**RE: Response to Comments and Transmittal of Pre-Design Investigation Work Plan Revision 1
Green Bay Former Manufactured Gas Plant
Green Bay, Wisconsin
Wisconsin Public Service Corporation
CERCLA Docket No. V-W-06-C-847, CERCLIS ID – WIN000509948**

PRE-DESIGN INVESTIGATION WORK PLAN REVISION 1 FORMER GREEN BAY MANUFACTURED GAS PLANT SITE

Project name **Former Green Bay MGP**
Project no. **70712**
Recipient **Wisconsin Public Service Corporation**
Document Type **Pre-Design Investigation Work Plan**
Revision **1**
Date **August 12, 2020**
Prepared by **Sarah Jo Martens**
Checked by **Staci Goetz**
Approved by **Brian Hennings**

FIGURE 4

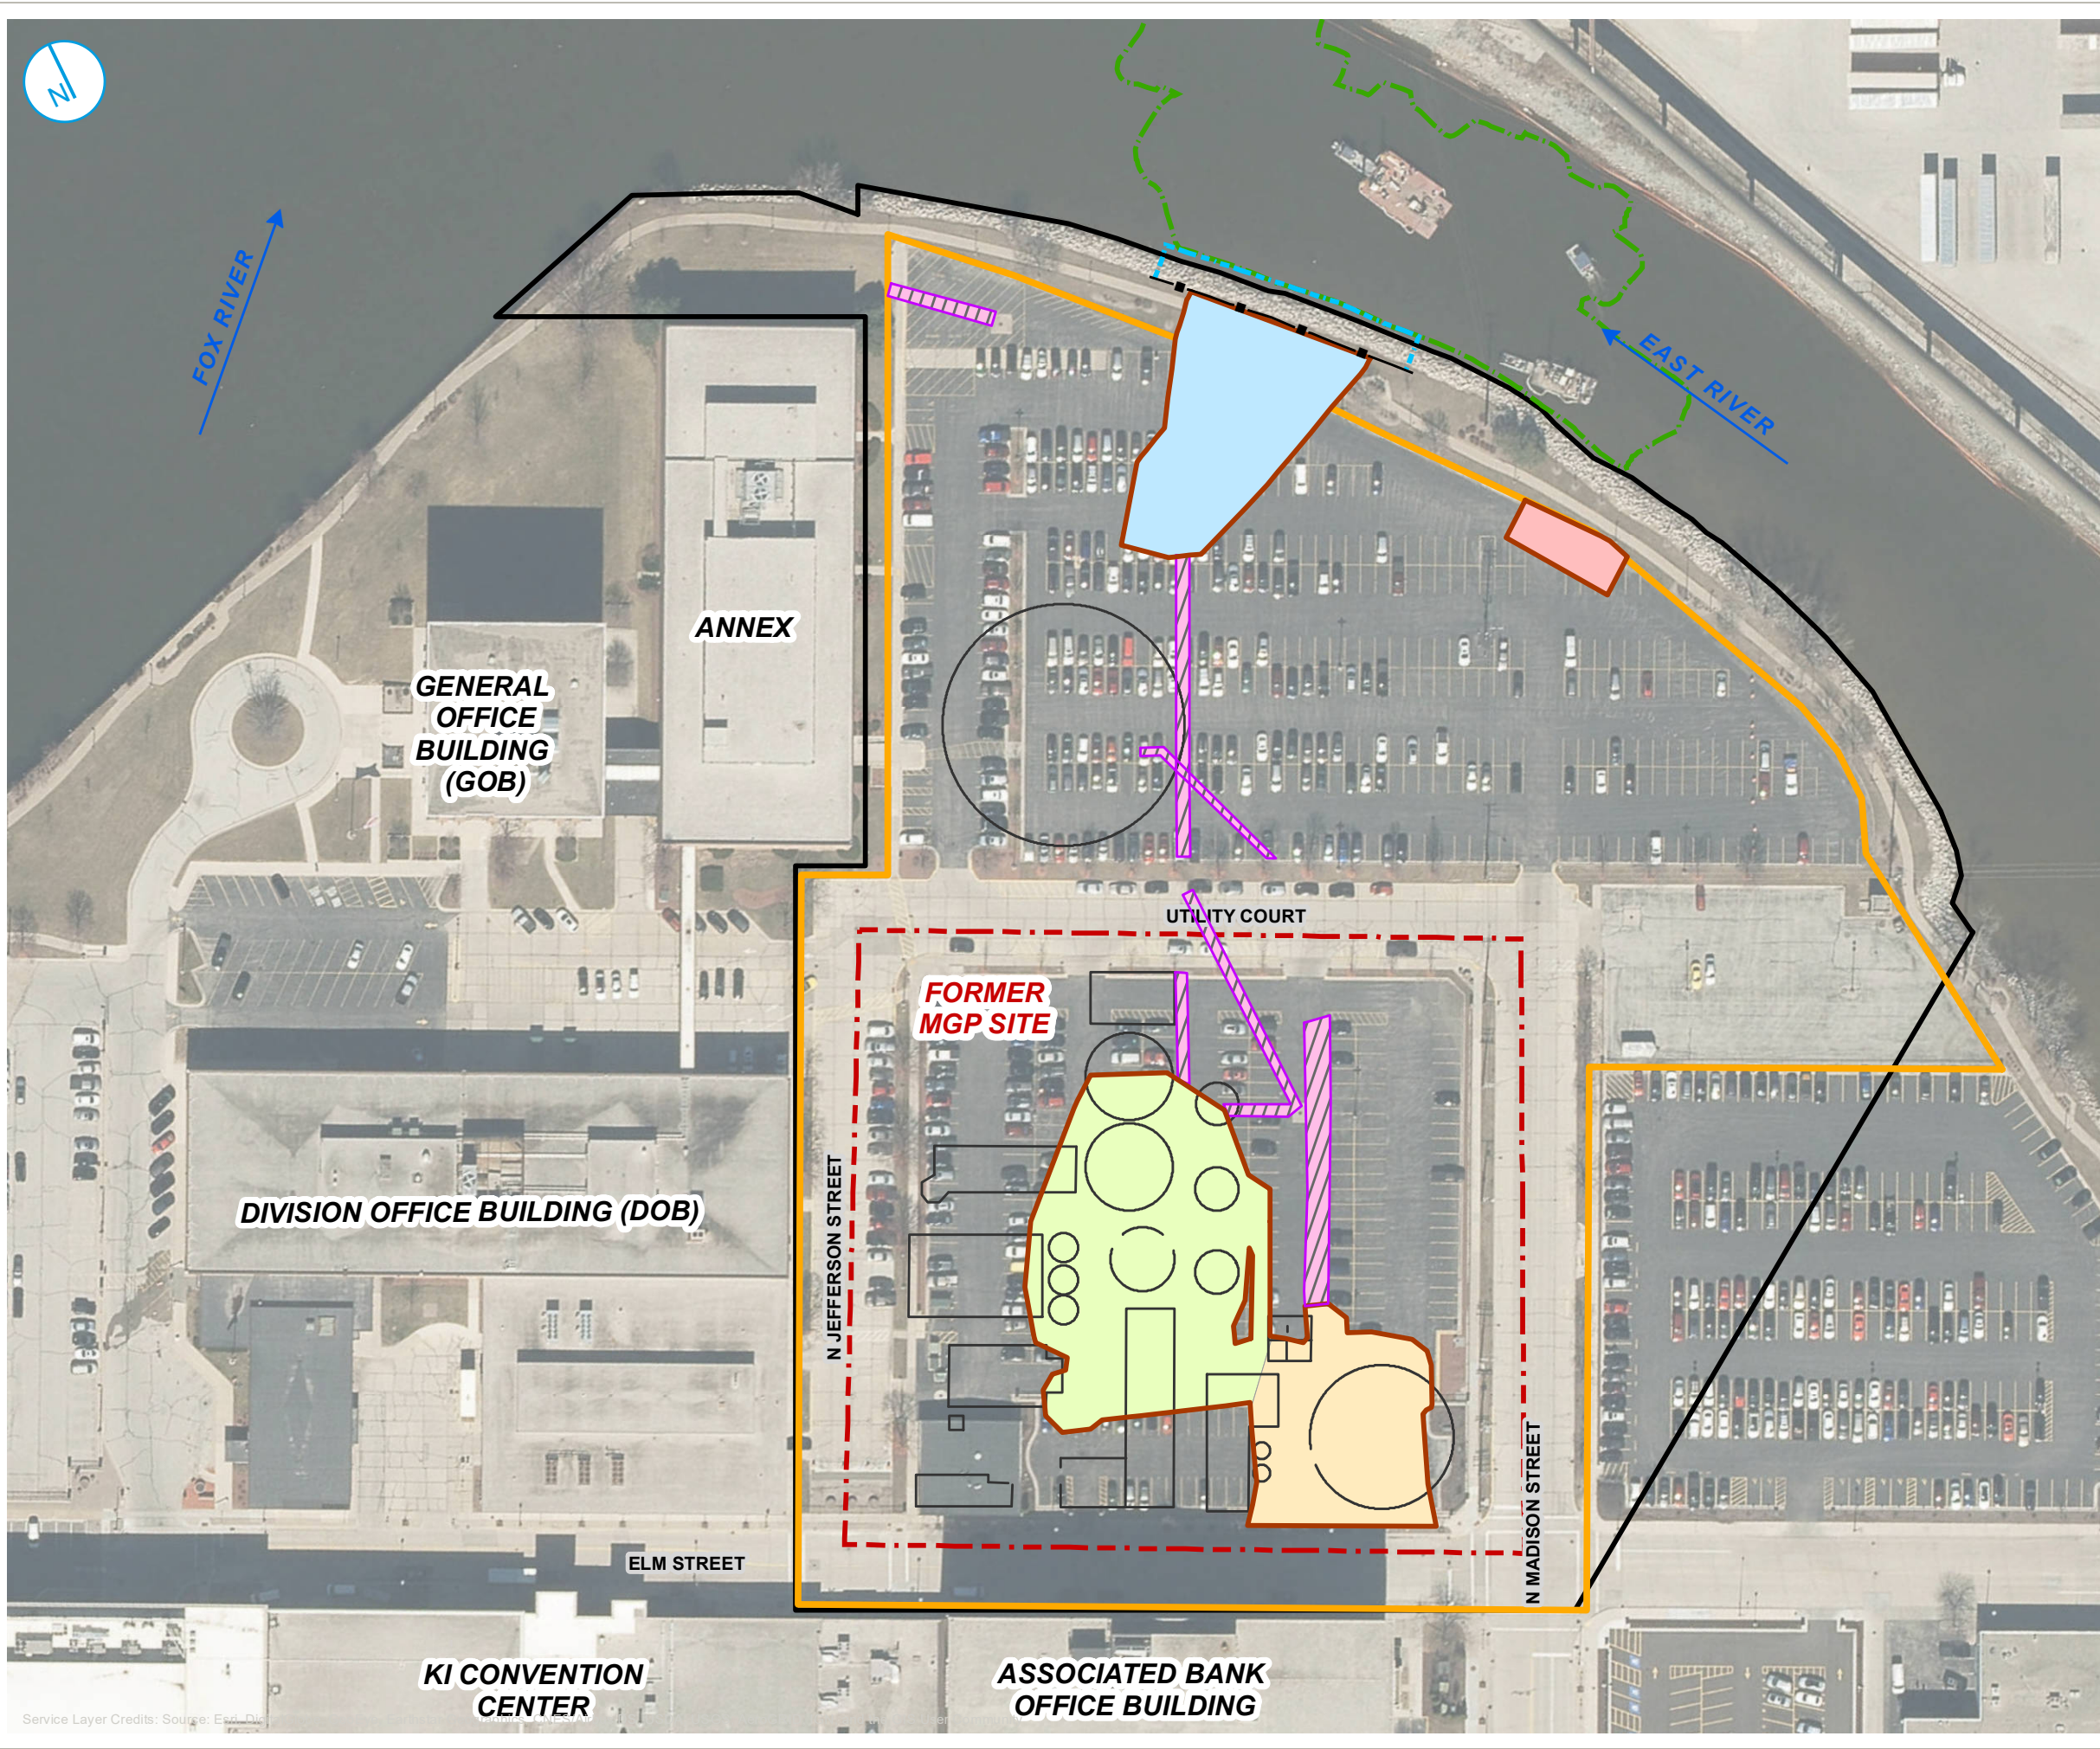
- 5. Section 1.4 - Please include a brief summary of the sheet pile wall and shoreline excavation activities that were performed to the northeast of Area 3, as shown on Figure 4. This summary should highlight the depth and conditions that prompted this work.*

18. Figure 4 - In the legend Excavation Area 1 is repeated and Excavation Area 4 is omitted. Please revise as appropriate.

WPSC Response: A summary of the 2018 shoreline soil removal has been incorporated within Section 1.5.

WPSC Response: Figure 4 has been revised accordingly.

FIGURE 5

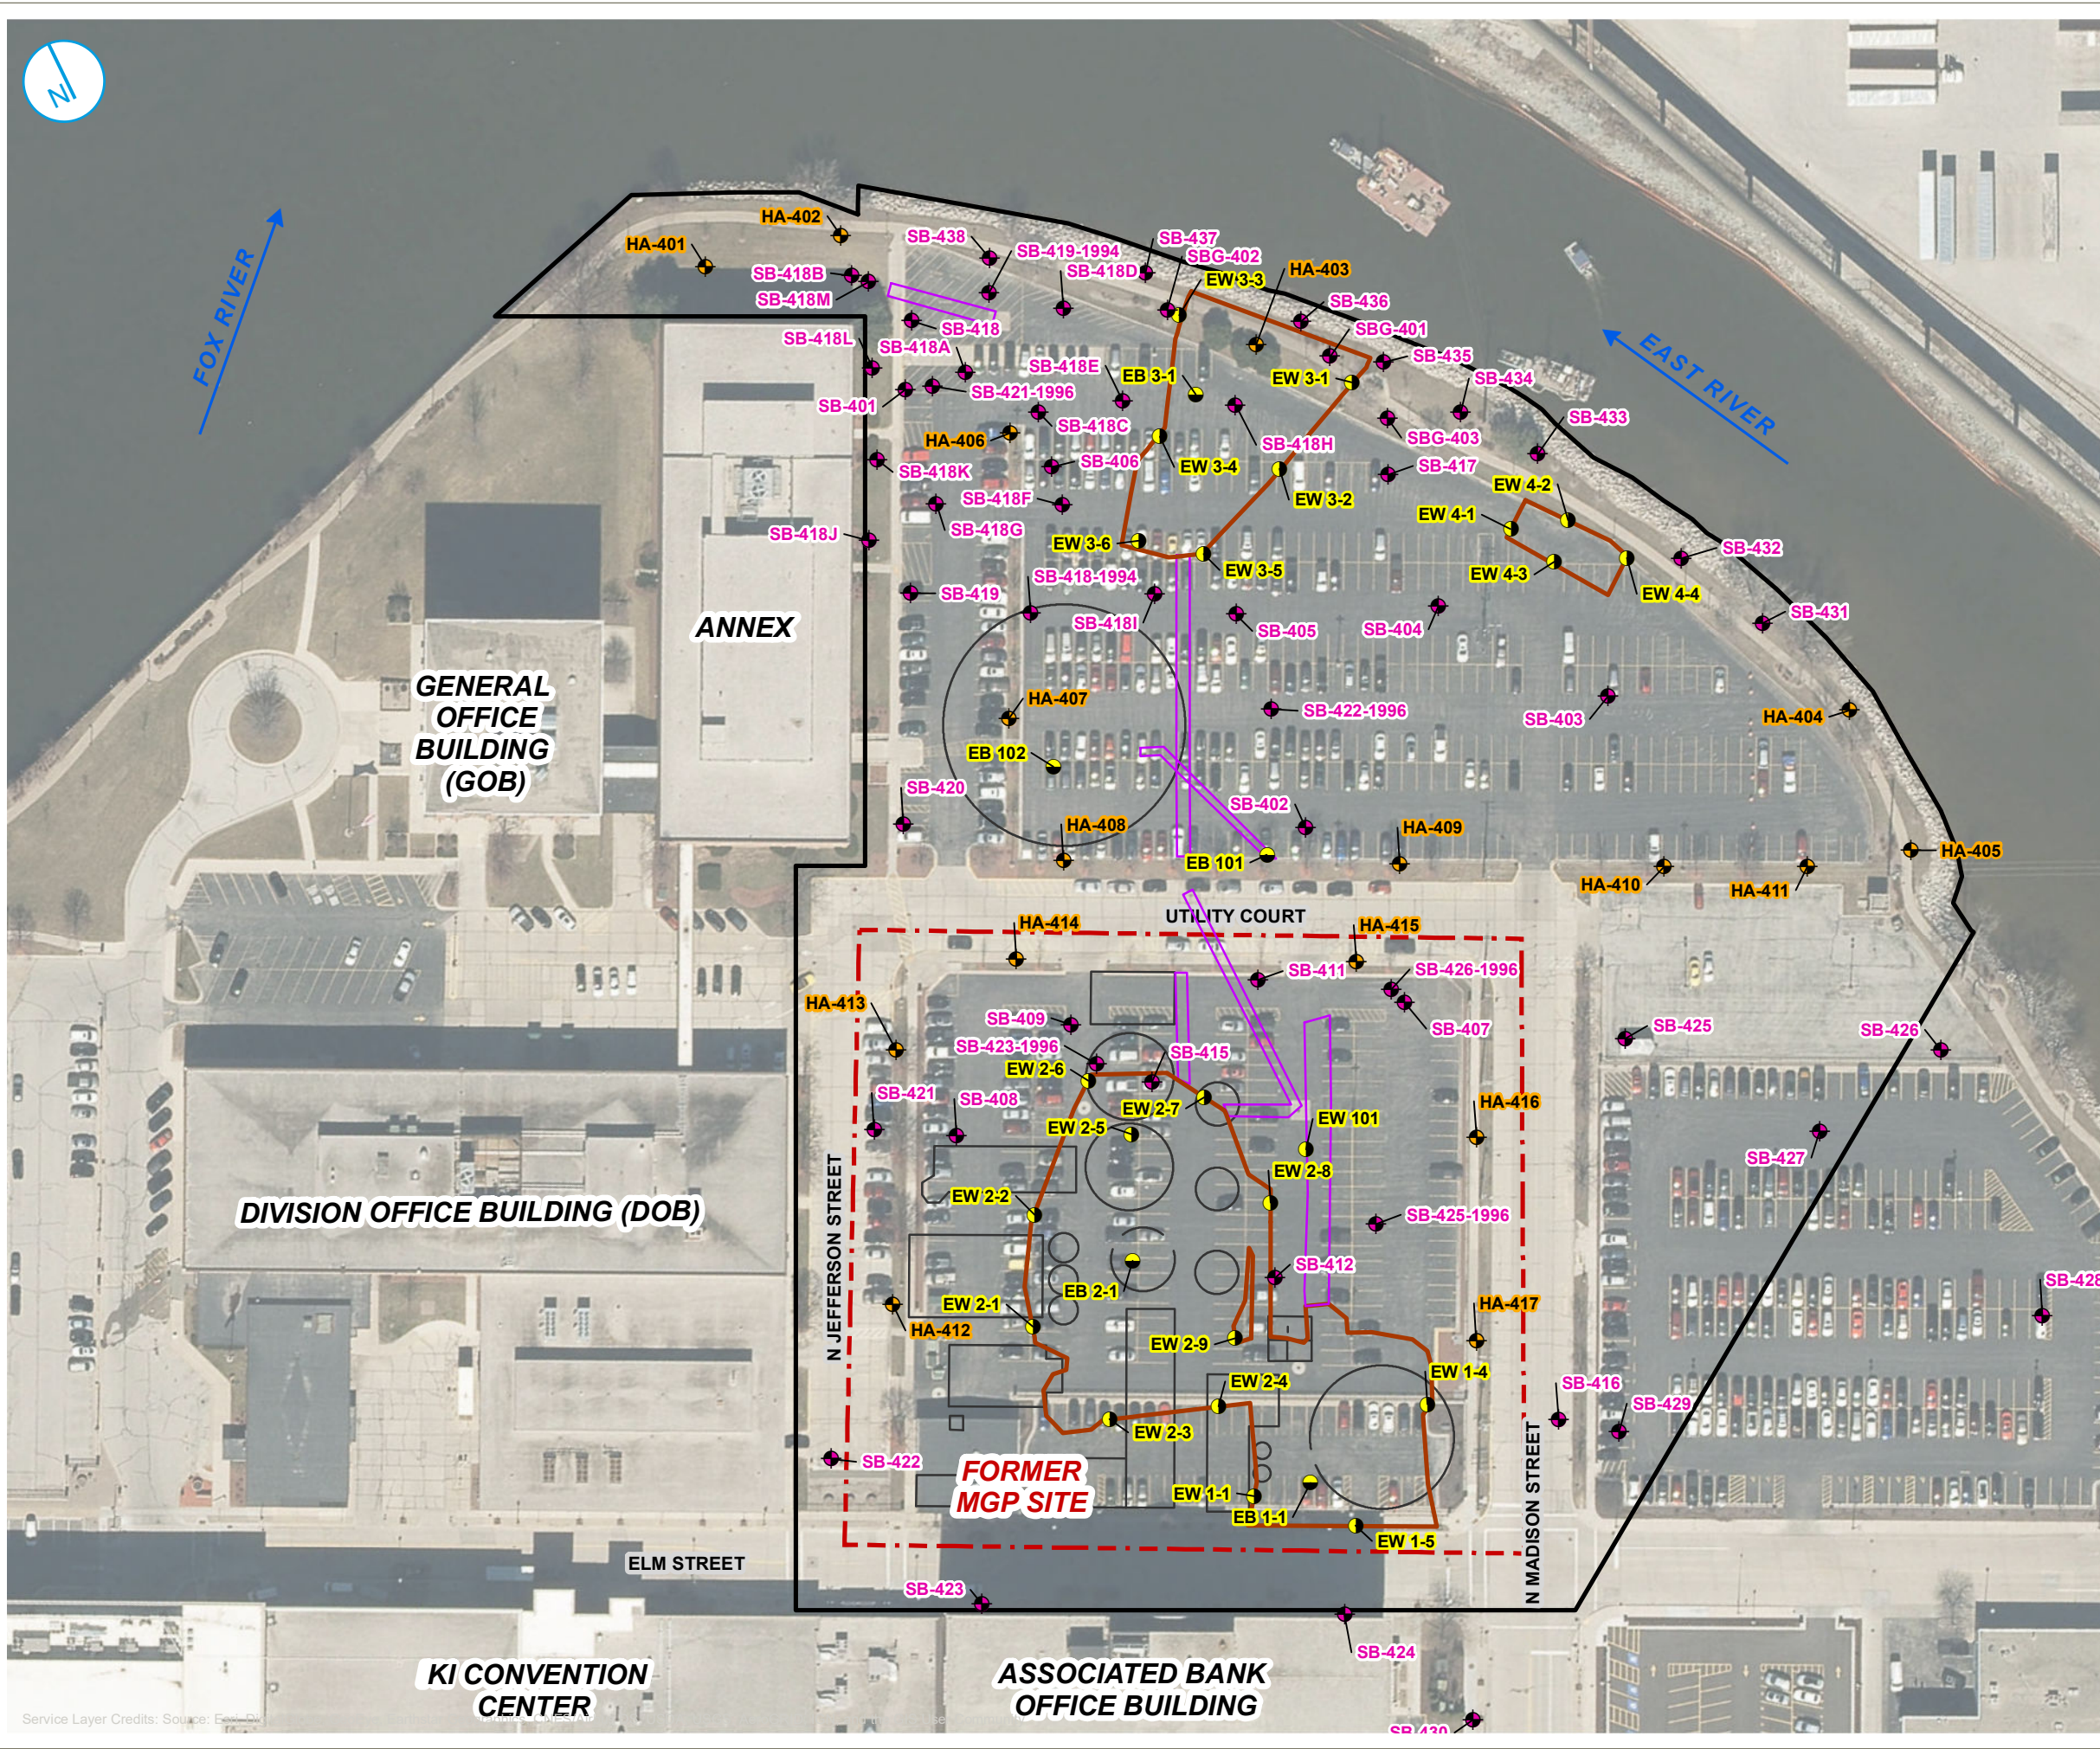
19. Figure 5 - The same symbol is noted for both the hand auger sampling and surface soil sampling location. Please review and change the symbol or the label accordingly.

WPSC Response: "Surface soil sampling" location label has been removed from Figure 5.
